The Naiad Frigate – Addenda

Addendum 1

Stem/Apron Patterns and Details

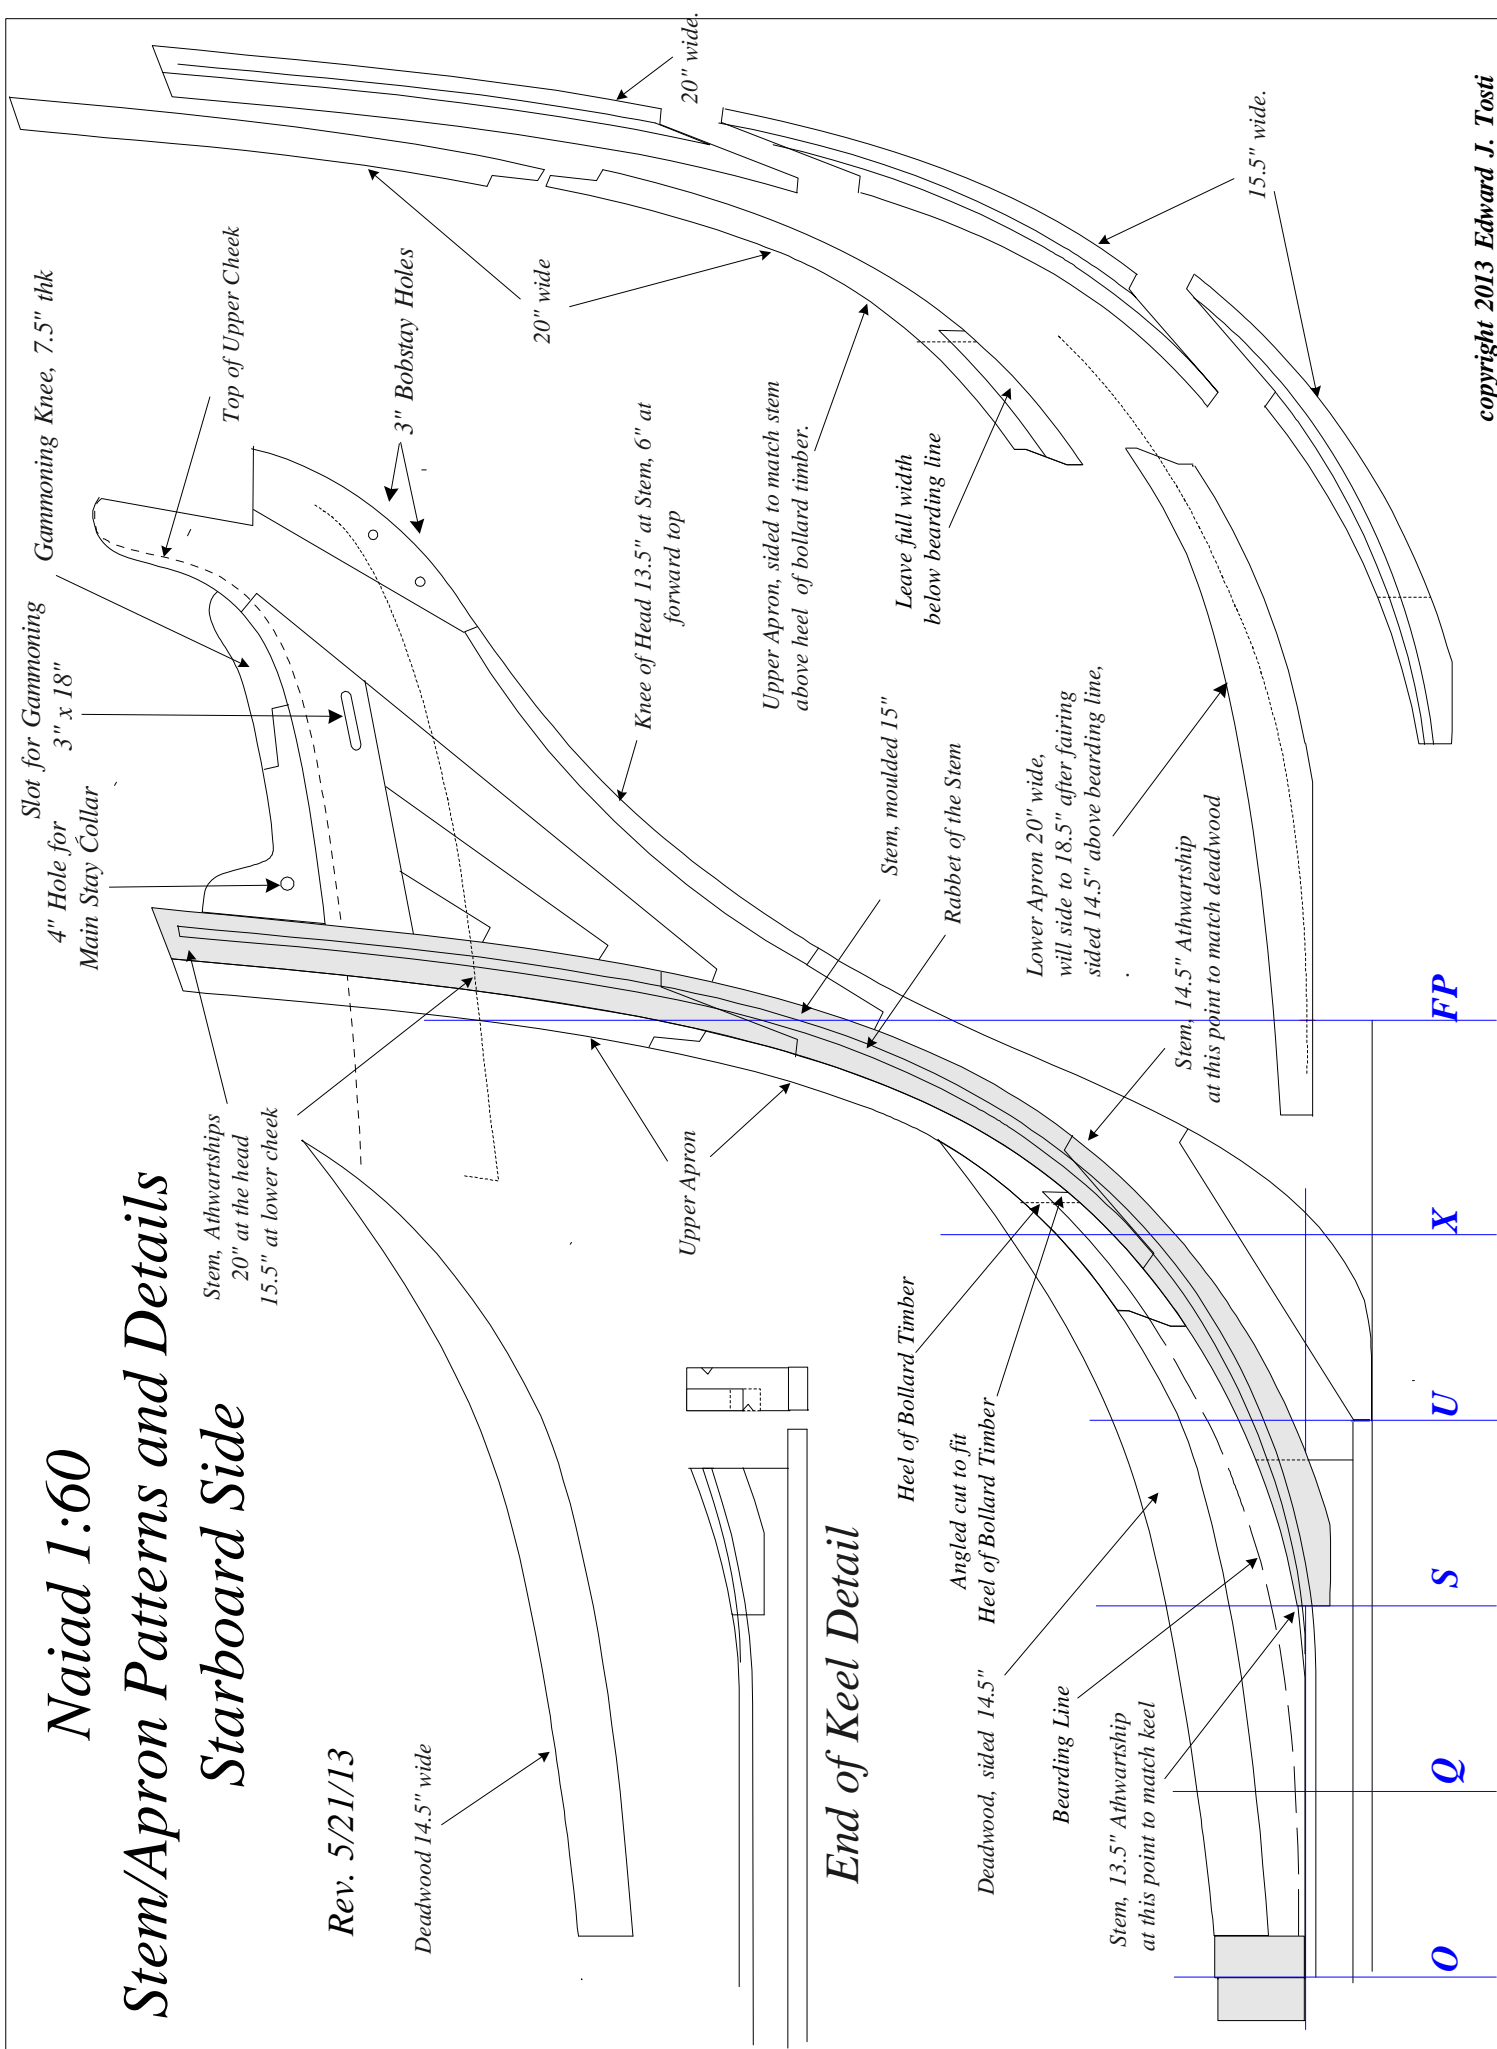
Attached are corrected pdfs for the two stem patterns sheets. The breadth of the pieces to be cut out for the lower stem were incorrectly shown as 13.5". The dimension should be 1'3.5" (15.5"). The following corrected pattern sheets are attached:

Deadwood 14.5" wide
